ADDENDUM No. 3

BID TITLE: Reference: File No. 29-24 2022 Multiple Park Site Improvements

Addendum #3– File No. 29-24 2022 Multiple Park Site Improvements

DESIGNED BY: SM DATE: 04/09/24
CHECKED BY: CM DATE: 04/09/24
DRAWN BY: MKSK F 02/2024
DATE: AS NOTED
SHEET NO: **L1.0A**

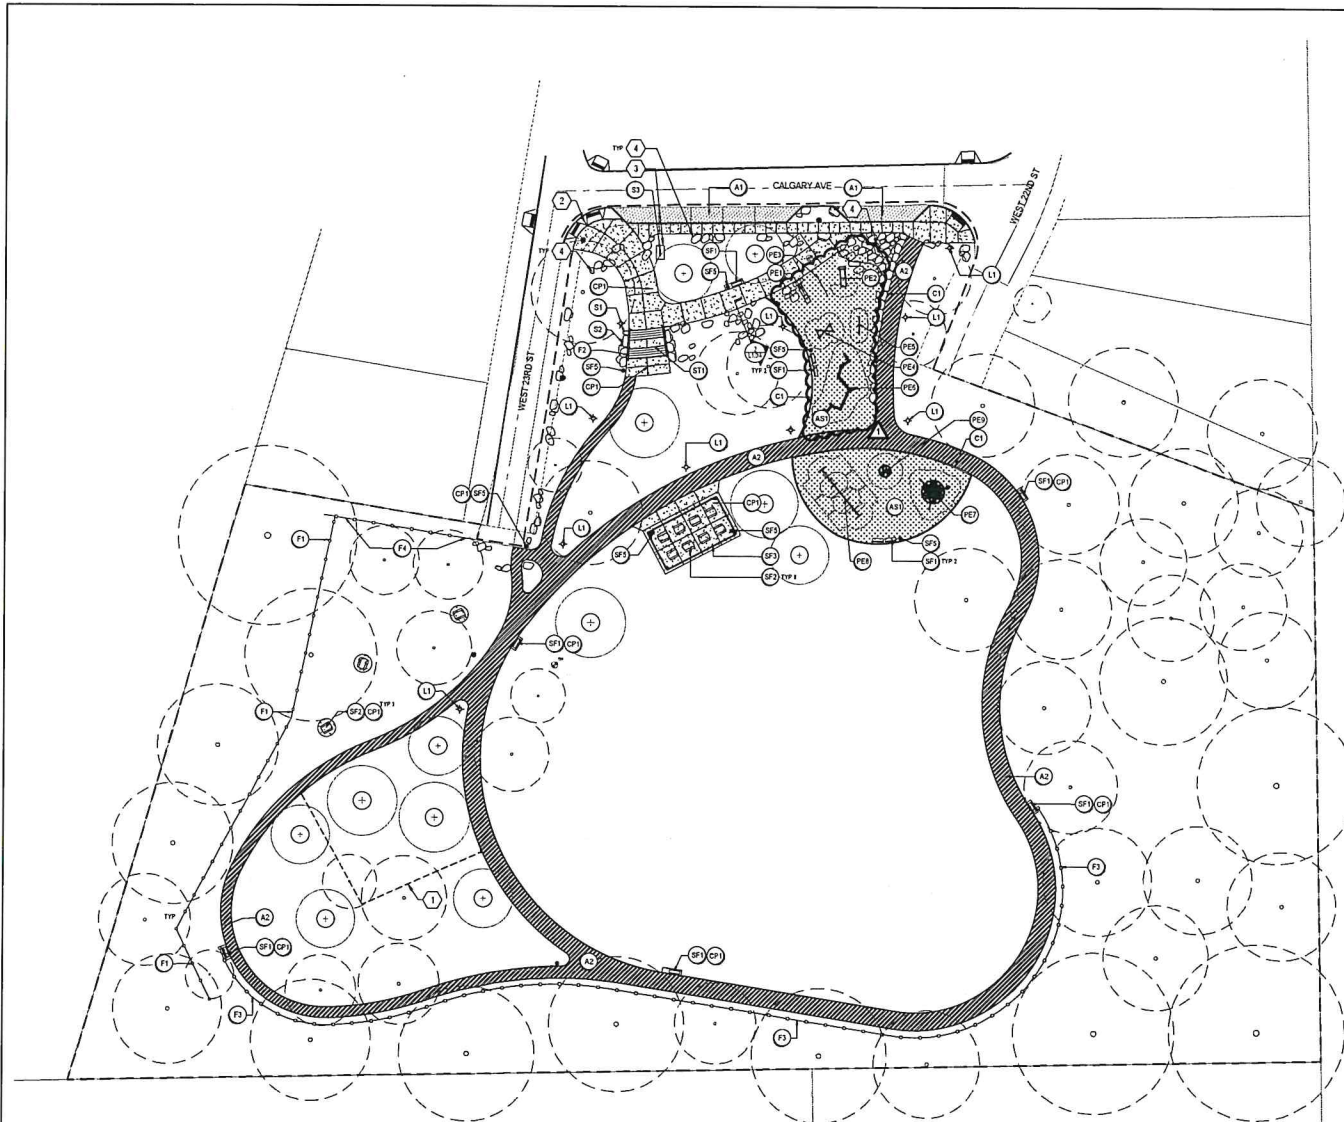
- There are no trees that will need to be removed from this park
- See L1.0A Coded Note 5 for site extent of tree pruning
- See C1.0A & C2.0A for added tree protection notes

- See L1.0A for approximate weight / truckload for materials/schedule of design minimums
- See 5.4A for means and methods of environmental graphics.

5 ASPHALT MULTI-USE PATH (CITY OF CLEVELAND STD. DETAIL)
SCALE: 1 1/2" = 1'-0"

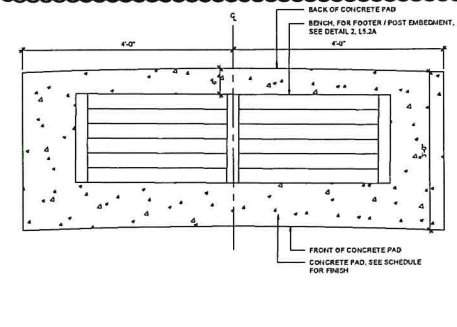
- Concrete Pavements: Thickened edges have been removed unless necessary.
- Detail 5/L4.0A – adjusted base course
- Detail 5/L6.0A – adjusted detail to match city standard
- Detail 10/L6.0A – clarification of aggregate
- L3.0A – Callout for curb, curb ramp and type 6, curbing
- L4.0A – Addition of bulkhead and asphalt road detail.

DESIGNED BY: DATE: 2/7/2024
CHECKED BY: DATE: 2/7/2024
PROJECT NUMBER: 2107
SHEET NO.: 20
SHEET NO.: C2.0A

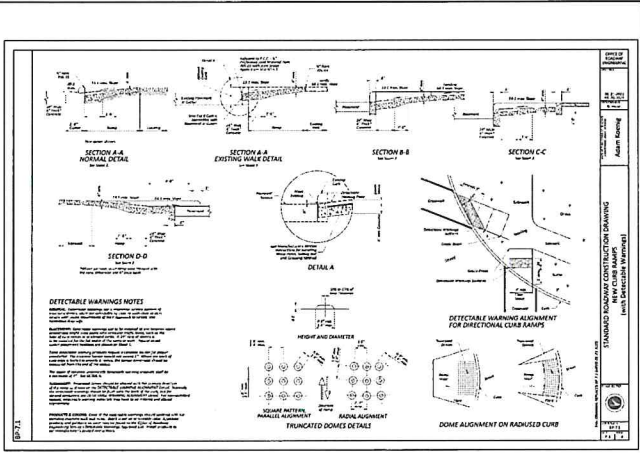
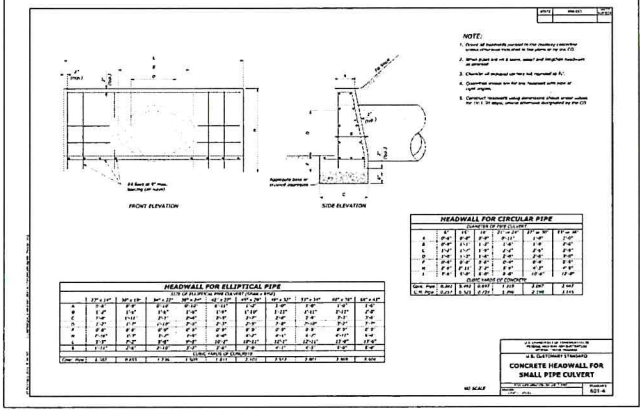
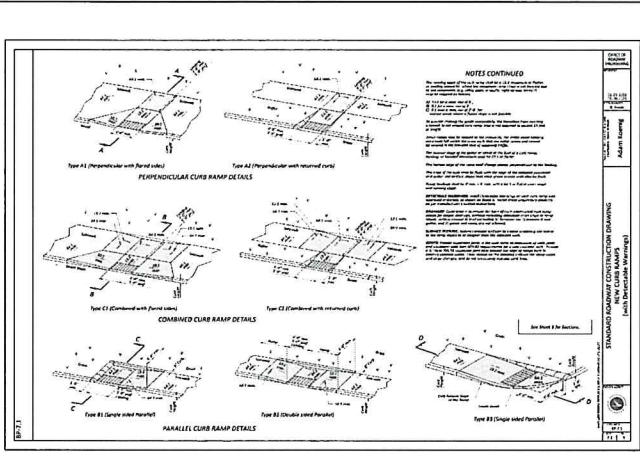
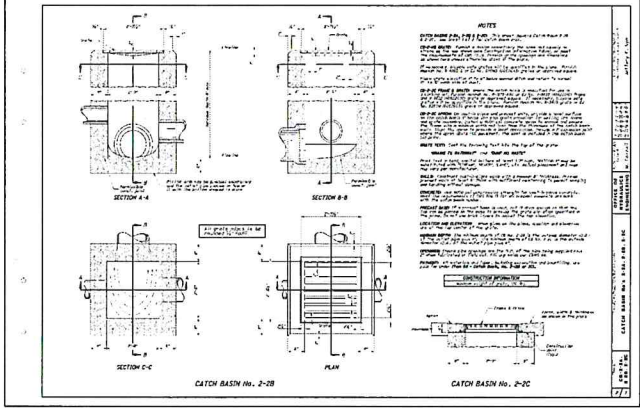
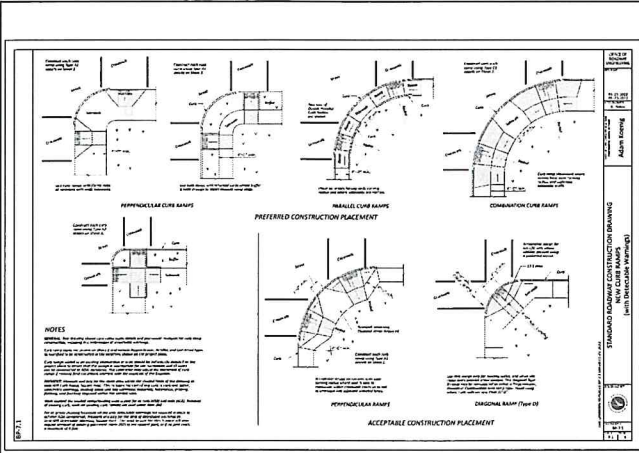
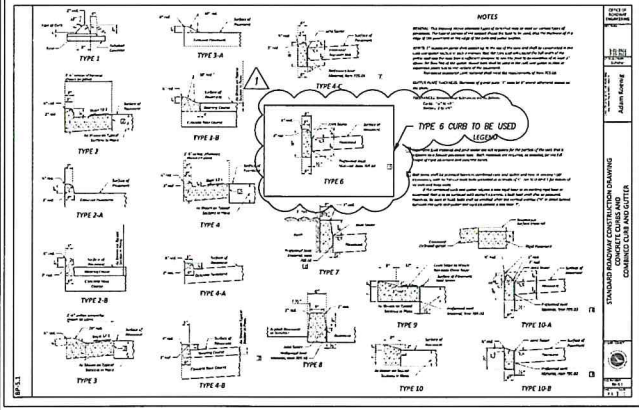
- See updated plan C2.0A

DESIGNED BY: BM DATE: 03/02/24
 DRAWN BY: CM DATE: 03/02/24
 PROJECT NUMBER: MKSK # C23054
 TITLE: AS NOTED
 SHEET NO: L3.0B

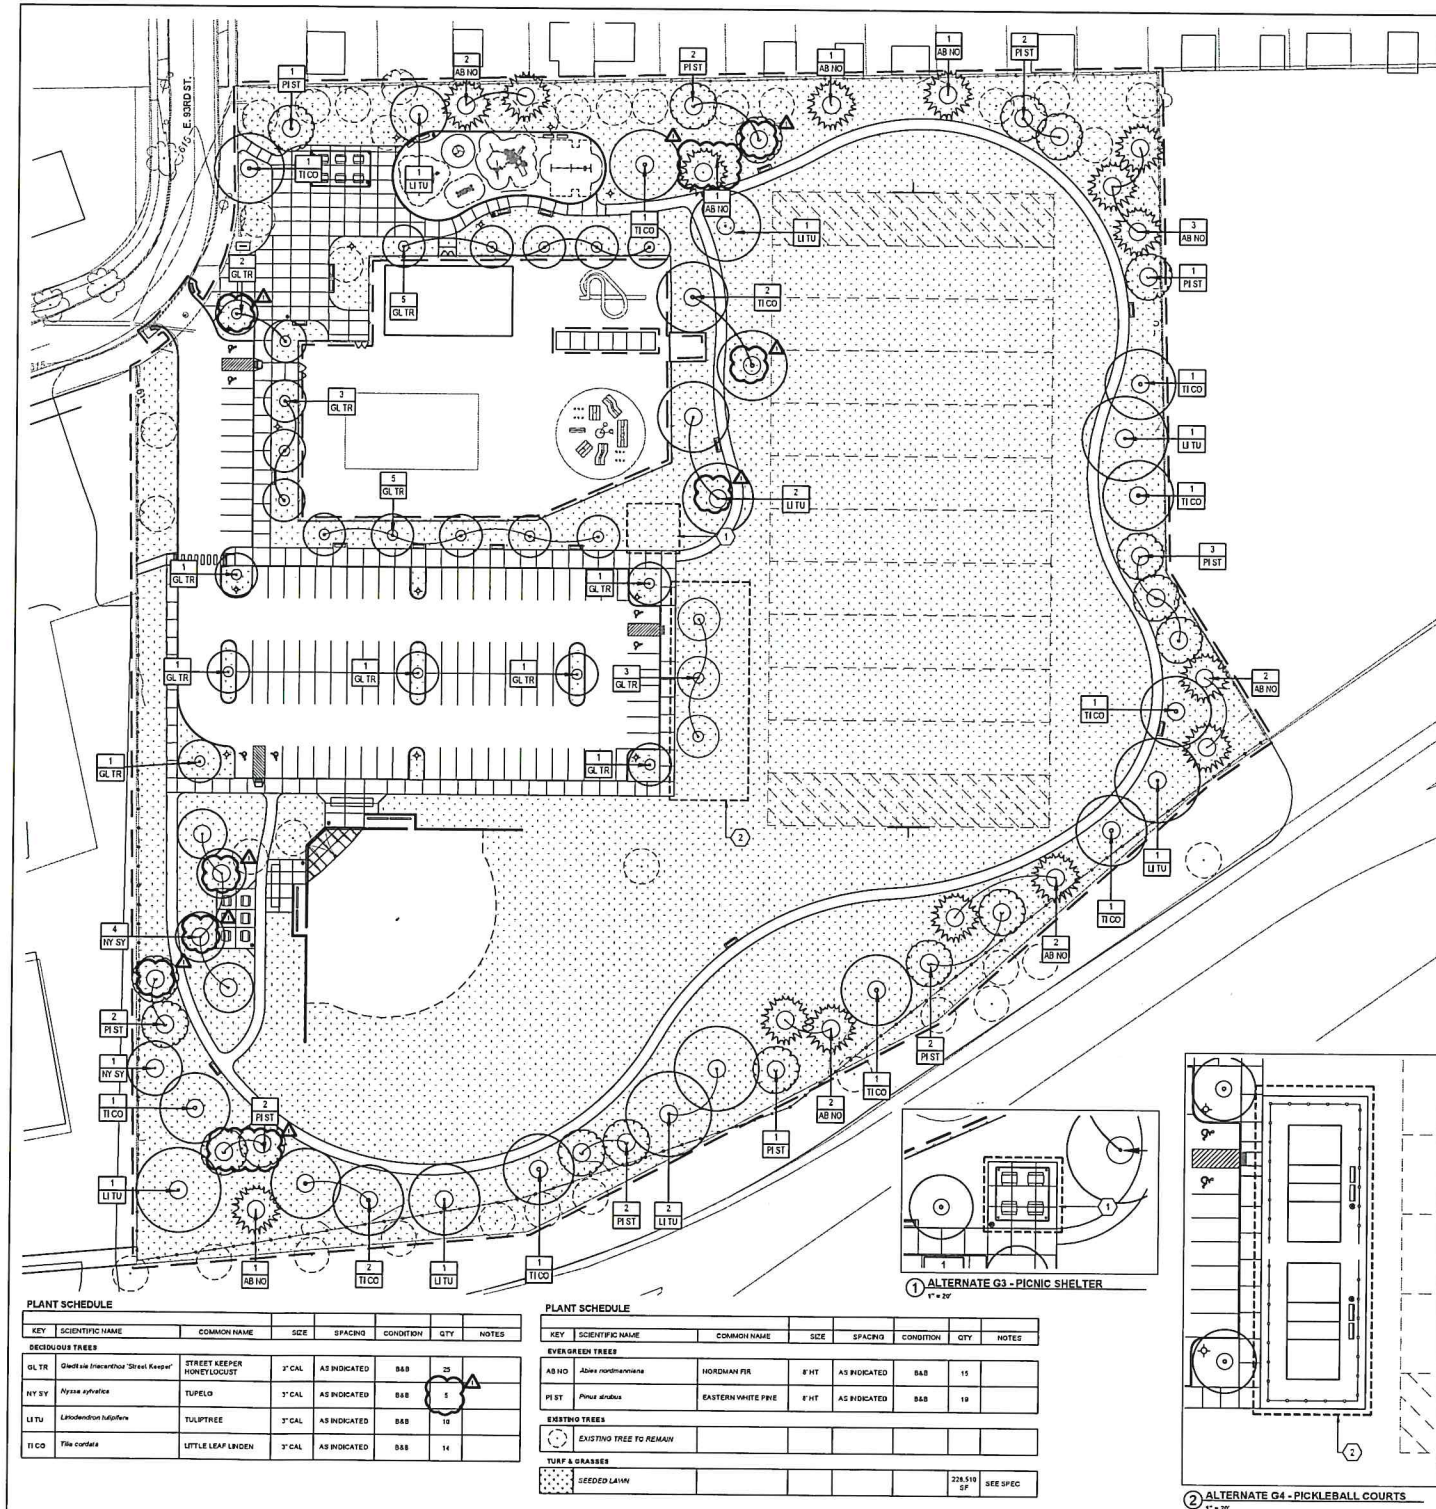
- L4.0B – New tree added above baseball field; picnic area due to utility conflict. Revised tree count in schedule of items
- L3.0B – Adjusted soils plan to reflect revised tree locations
- See C1.0B for added tree protection notes

5 PLAY SURFACE W/ ASPHALT BASE
SCALE: 1 1/2" = 1'-0"

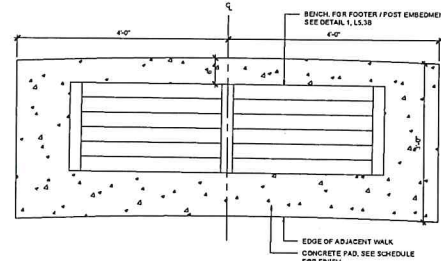
- Concrete Pavements: Thickened edges have been removed unless necessary.
- Detail 5/L5.0B – adjusted detail to match city standard
- Detail 6/L5.0B – adjusted base course dimension
- Detail 7/L5.0B – clarification of aggregate
- L2.0B – Callout for curb detail
- L3.0B – Callout for curb detail
- L4.0B – Addition of trench detail and asphalt mil and fill detail.
